City of Sammamish

Louis Thompson Road Tightline Project

Q&A May 2, 2024

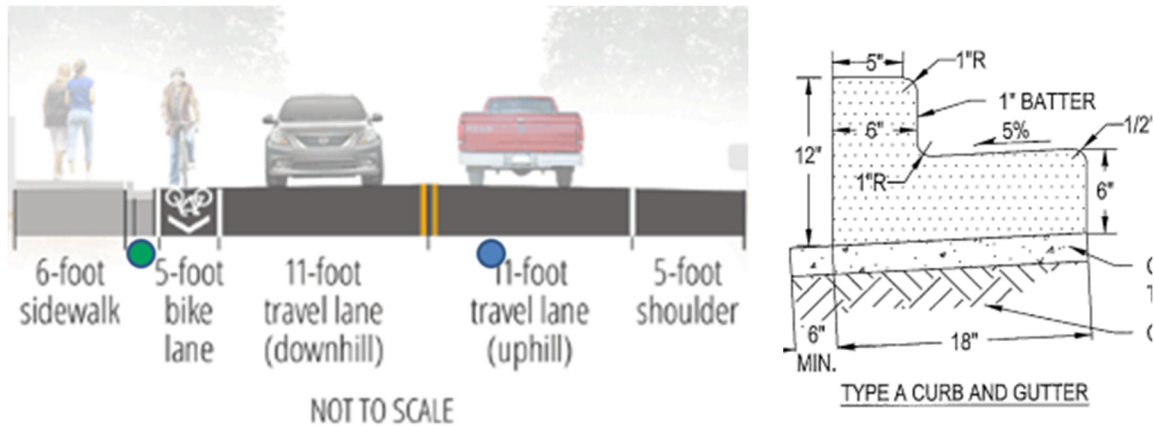
8. How does the project plan for sheet flow or surface water runoff?

The steep side street approaches intersecting Louis Thompson will have some limited sheet flow that cannot be fixed by a road project. Most of the water will enter the stormwater system from the private roadside ditches. However, some relatively small areas of the private streets (e.g. approximately 800 square feet of 210th Place SE) will continue to contribute some limited sheet flow. This can happen at intersections where the road surface of the steep side streets have an angled approach and change cross slope in the final approach to the intersection. This is a relatively small contribution of flow and cannot be fixed by an extra storm drain or two within City right-of-way because the sheet flow is not concentrated – it is low and widely distributed. Storm drains are rarely installed within intersections or in the driving lanes of streets – it is not standard roadway design practice to grade low spots for sheet flow collection within travel lanes or intersections.

Surface water runoff from private roads and driveways frequently drains onto public streets. This condition is prevalent throughout Western Washington and does not reflect a design shortcoming or suggest corrections are necessary.

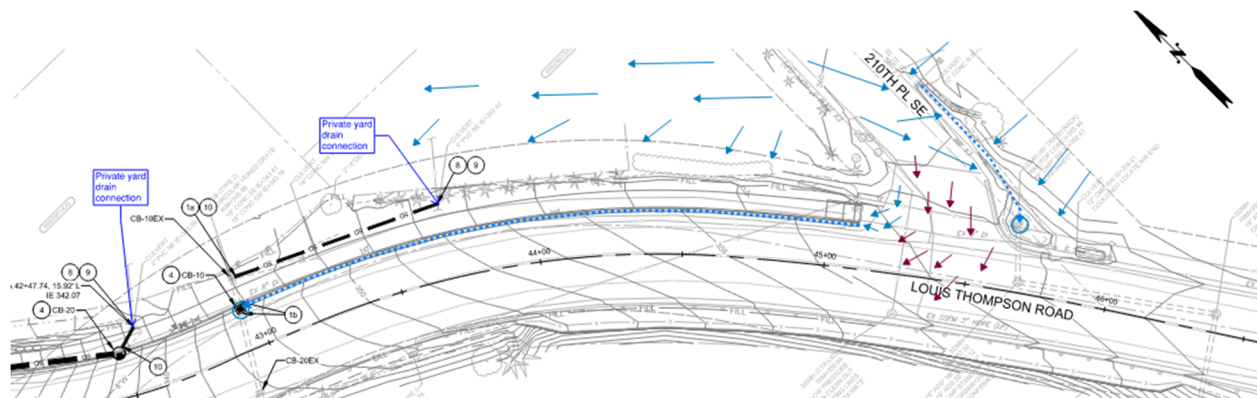
11. Does 210th Place SE need additional pipe or storm drains?

No. Most of the surface water runoff from 210th Place SE, a private road, flows along a private ditch and then into a storm drain on the southeast corner of 210th Place SE. The storm drain was replaced in 2018 with a birdcage inlet structure (photo, right) for maintenance purposes to reduce the amount of leaves, branches, and debris that enter the storm pipe.

The majority of the flow from Tamarack arrives by the privately maintained ditch. The curb and gutter will take flows to the northwest to the next storm drain. The ditch that is being replaced below 210th Place SE did not provide detention for Tamarack. It is being removed to reduce impacts from high flows leading to erosion within the ditch and sediment transfer.
